3.0 Site-Specific ITAAC

Table 3.0-1 ~~Table 9.3-4~~ Ultimate Heat Sink (UHS)

Figure 3.0-1 ~~Figure 9.3-1~~ UHS and Reactor Service Water System

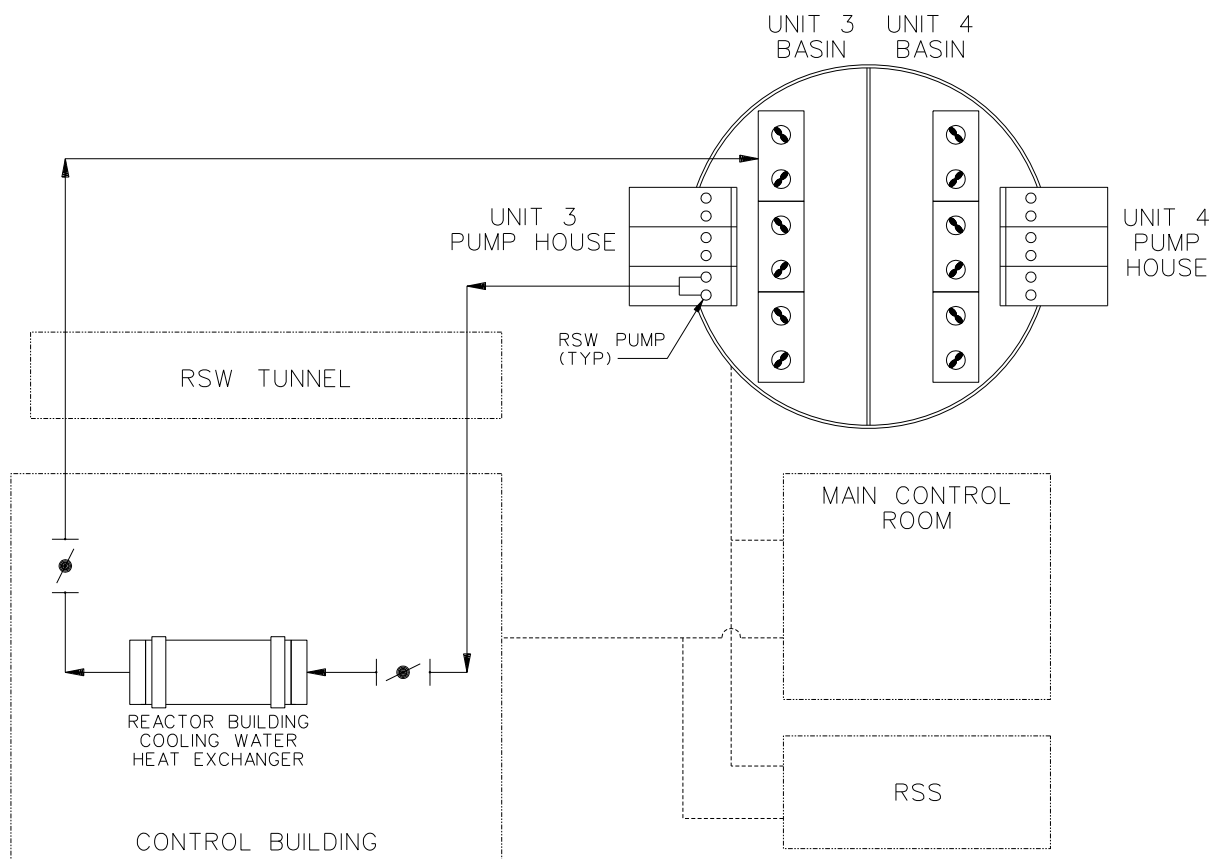
Design Requirement	Inspections, Tests, Analyses	Acceptance Criteria
1. The basic configuration of the UHS is as shown on Figure 9.3-4 3.0-1.	1. Inspections of the as-built system will be conducted.	1. The as-built UHS conforms with the basic configuration shown on Figure 9.3-4 3.0-1.

4. Displays and controls in the main control room and remote shutdown system (RSS) are provided for required functions of the UHS system.	4. Inspections will be performed on the main control room and RSS displays and controls for the UHS system.	4. Displays and controls exist in the main control room and as shown on Figure 9.3-4 3.0-1.

Design Requirement	Inspections, Tests, Analyses	Acceptance Criteria
1. The basic configuration of the site-specific RSW is as shown on Figure 9.3-1 3.0-1.	1. Inspections of the as-built system will be conducted.	1. The as-built RSW conforms with the basic configuration shown on Figure 9.3-1 3.0-1.

5. Displays and controls in the main control room and RSS are provided for required functions of the RSW system.	5. Inspections will be performed on the main control room and RSS displays and controls for the RSW system.	5. Displays and controls exist in the main control room and RSS as shown on Figure 9.3-1 3.0-1.
